August 30, 2012

RE: Revisions to Antrim Wind Energy Alteration of Terrain permit application,
No. 120131-015, and Section 401 WQ Certification Request

PLAN: MAIN ACCESS ROAD
STA 165+00 TO 183+20
ANTRIM WIND ENERGY, LLC
ANTRIM WINDPARK
NEW HAMPSHIRE

C-12

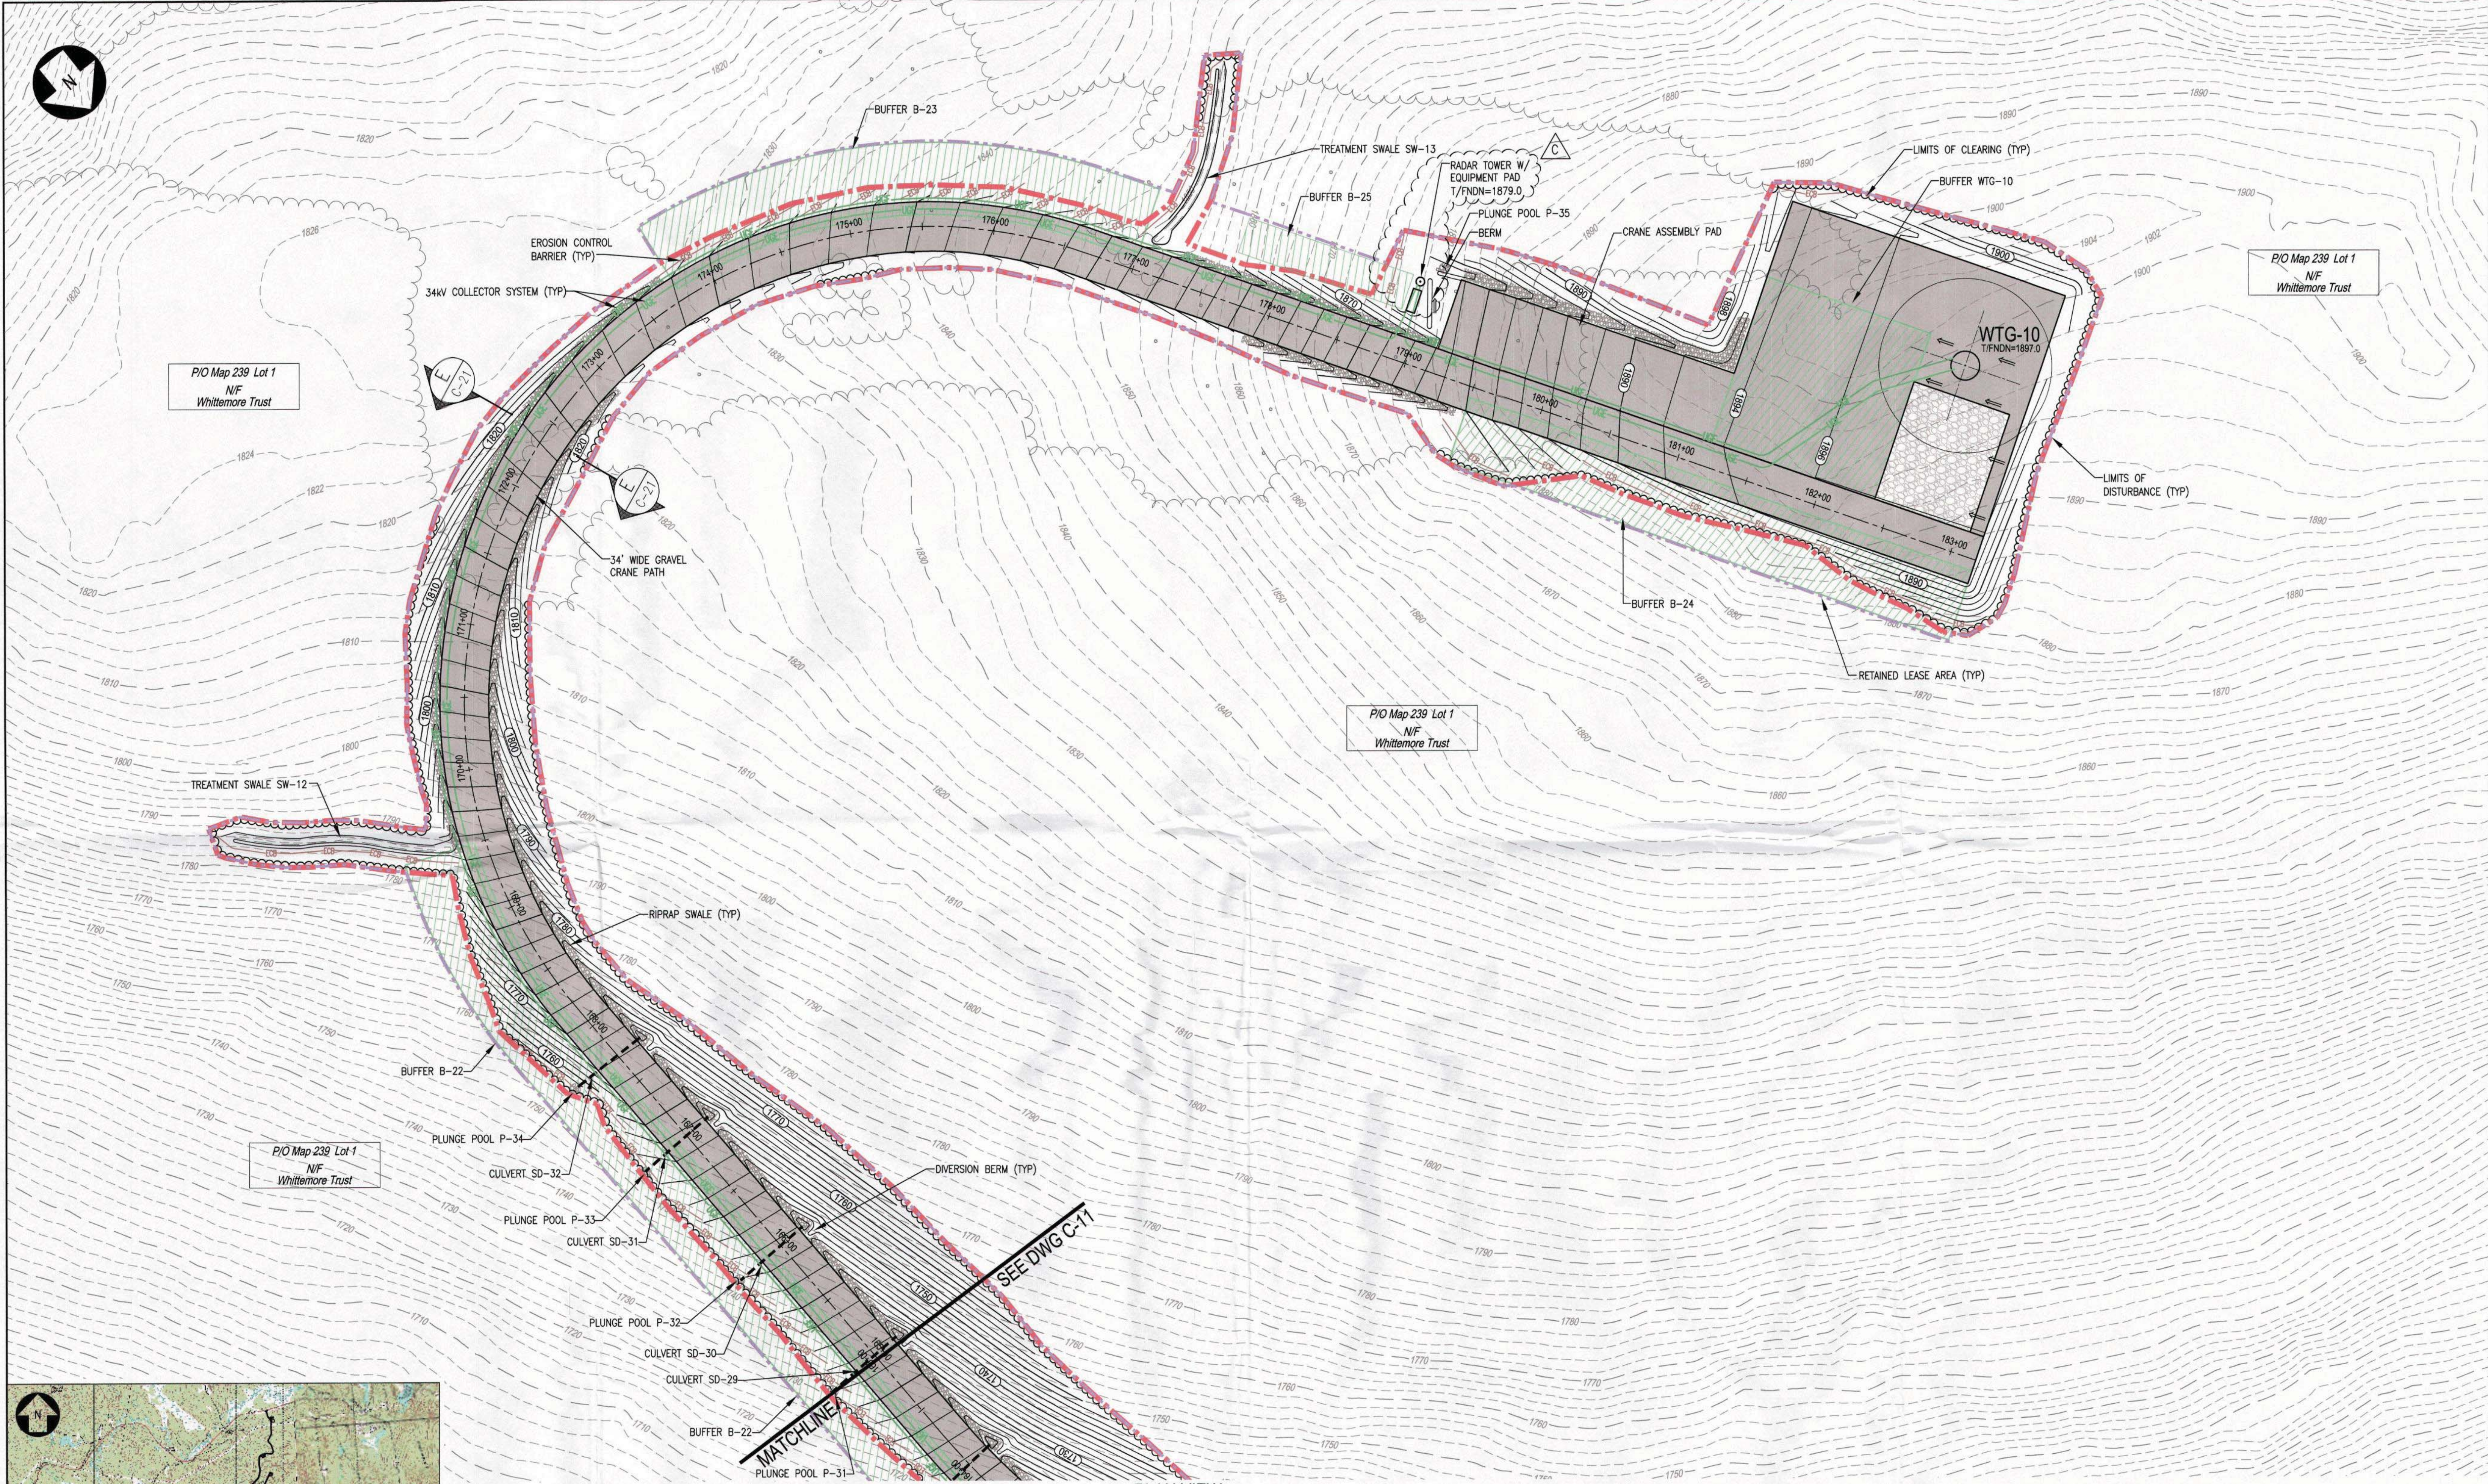
The addition of the radar tower will change the total impervious area from the site from 500,940 square feet to 501,065 square feet, an increase of 125 square feet, and civil design plans are revised for sheets C-12, C-17, C-20, and G-3, which depict the details the radar tower and radar tower site. These changes will need to be reflected in the Alteration of Terrain permit application under 6.C. and 7., respectively.

NO.	REVISION	DATE	BY	CK	P.E. STAMPED	P.E. No.
C	ADDED RADAR TOWER LOCATION	8/27/12	PMM	PGT	DTB	8105
B	ISSUED FOR PERMITTING	1/20/12	PMM	PGT	DTB	8105
A	ISSUED FOR CLIENT REVIEW	12/19/11	PMM	PGT

OVERALL LOCATION MAP & DRAWING INDEX ANTRIM WIND ENERGY, LLC ANTRIM WINDPARK NEW HAMPSHIRE	ANTRIM	TRC 249 WESTERN AVENUE AUGUSTA, ME 04330 PROJECT NO: 186317 DATE: 11-8-11	G-3	REV. C
--	--------	---	-----	-----------

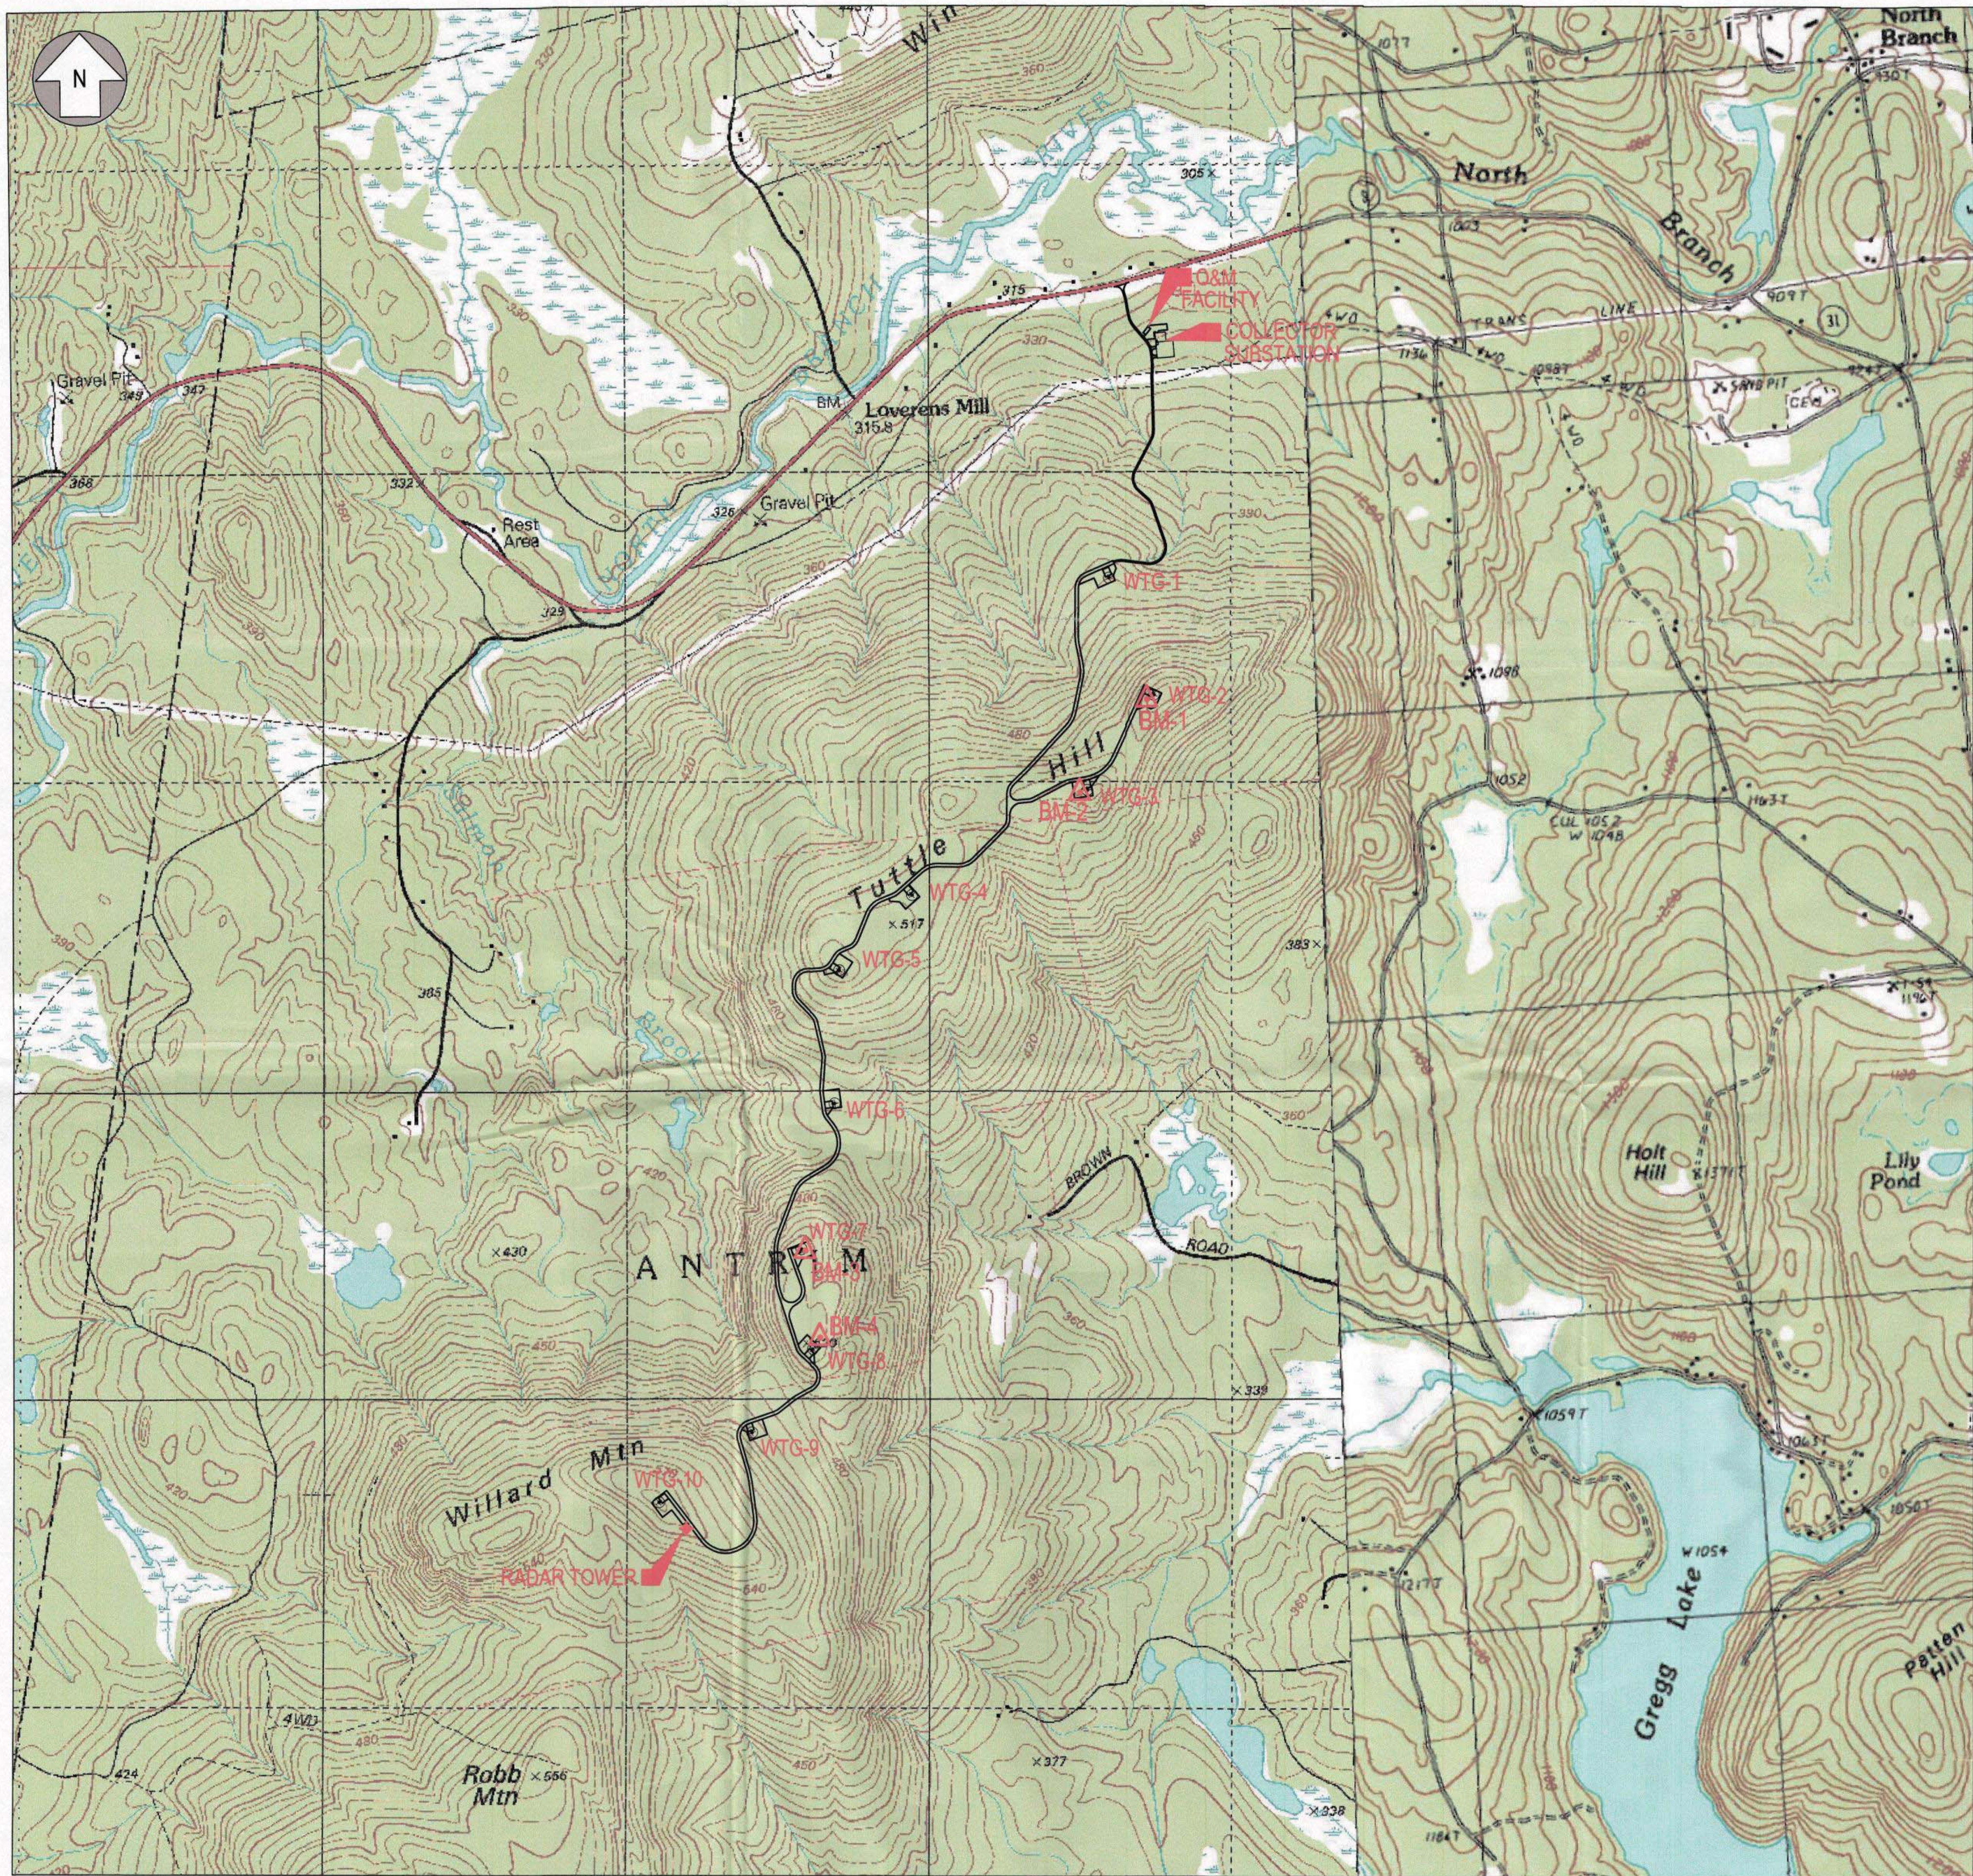
The stormwater plans, specifically Sheets WS-2, WS-3, and SW-12, have been revised to reflect this change as well. Sheets WS-2 and WS-3 show the proposed location of the radar tower in relation to the watersheds and site soils respectively. Sheet SW-12 shows a more detailed view of the tower location relative to WTG-10. A Small Pervious Area buffer, labeled B-25, has been designed to meet the project Water Quality requirements for this new impervious area. A buffer design calculation sheet is included with this submittal.

NO.	REVISION	DATE	BY	CK	P.E. STAMPED BY	P.E. No.
D	ADDED RADAR TOWER LOCATION	8/27/12	PMM	PGT	DBT	8105
C	REVISED PER DEC REVIEW COMMENTS	6/1/12	PMM	PGT	DBT	8105
B	ISSUED FOR PERMITTING	1/20/12	PMM	PGT	DBT	8105
A	ISSUED FOR CLIENT REVIEW	12/19/11	PMM	PGT
